**Comments by Rye Conservation Society  
on policies contained within the  
Rye Neighbourhood Plan  
Pre-submission version. Policies as set out  
in RNP shown in blue.  
Where RCS believes an alteration to the  
policy title is needed, this is shown in red.**

**Rye Conservation Society  
6 April 2018**

**View of potential development site H7  
from Hilders Cliff**

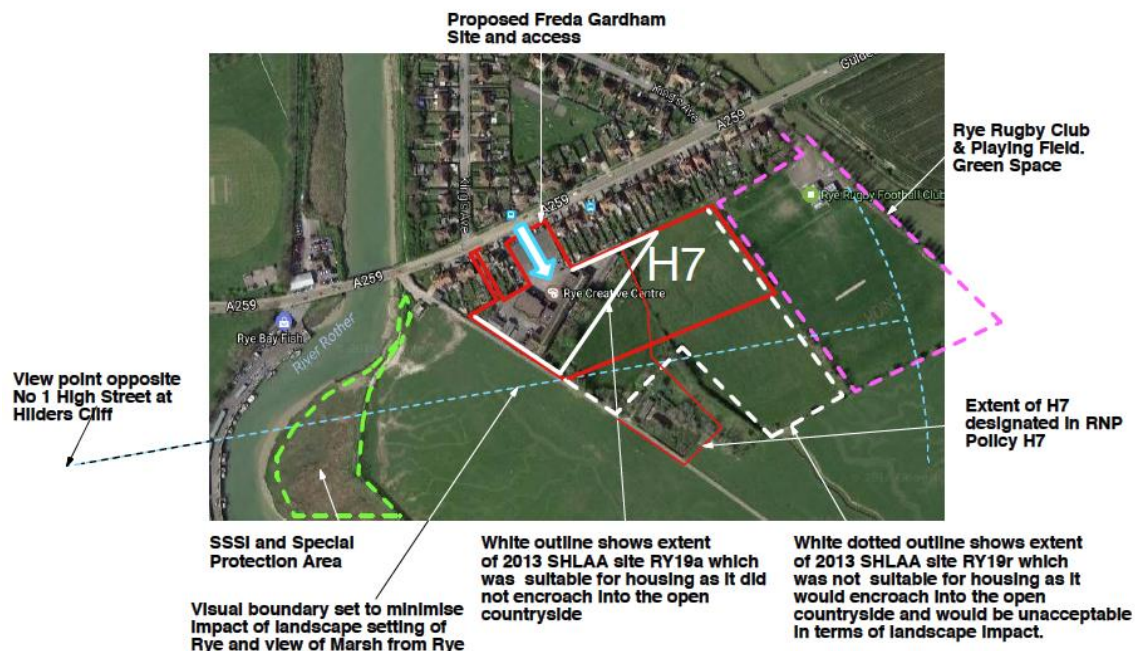
The Society is concerned that the site H7 as set out in fig 10 will be unacceptable in terms of landscape impact as it would encroach into the open countryside. This was confirmed in the 2013 SHLAA report, see site RY19r. We are particularly concerned on the impact that this current site designation will have on the wider landscape and on the Marsh when viewed from Rye itself. We believe that it is in conflict with the thrust of RNP Policy E1.

The Society is of the view that the area of the site should be reviewed and revised with greater emphasis placed on the setting of Rye and of the open views from Rye to the Marsh. The effect of the development of the current site H6 on the long views towards the Marsh are shown on the attached diagram.

Fig 12

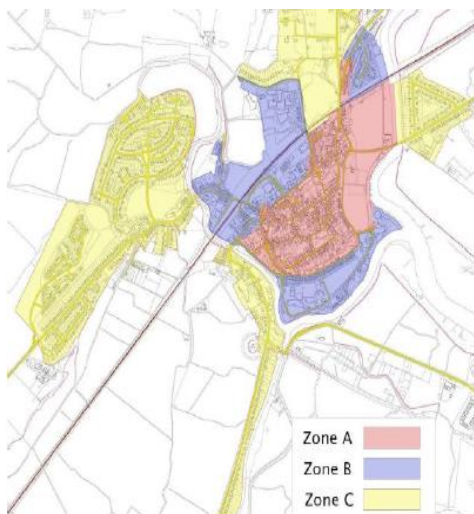
The Society is concerned that Fig 12 indicates that Zone B includes areas such as King's Avenue which are entirely residential and where development of micro-businesses could result in loss of residential amenity. We note that Fig 17 does not indicate Zone B at all. We believe that the areas for micro-businesses should be more clearly defined.

Fig. 17

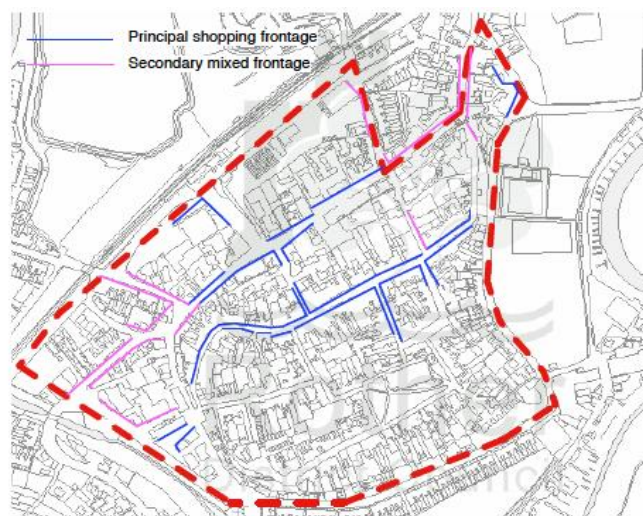
It is the Society’s view that Fig 17 gives an inaccurate indication of the Core Town Centre Area as it is an update of the Rye Shopping Area which formed part of the 2006 Local Plans map. It does not include the largest convenience shop i.e. Costcutter’s.

Over the intervening years, the variety of uses within the Core Centre has expanded with the growth of holiday accommodation including Airbnb, cafés and restaurants, the increased emphasis on comparison shopping i.e. visitor spend, and on cultural activities such as Kino. It is no longer traditional retail and residential. With the Permitted Development regulation in respect of changes within the retail and business classes, any designation of uses will be out of date within a short period. We therefore believe that it would be better to designate the area shown on the plan below. If it is necessary to delineate the shopping areas, this could be done by highlighting the principal shopping frontages on the plan. This would also allow for the designation of secondary mixed-use frontages such as Landgate, where low footfall may make retail usage uneconomic and a more mixed use could be allowed.

Alternative delineation of Core Town Centre Area
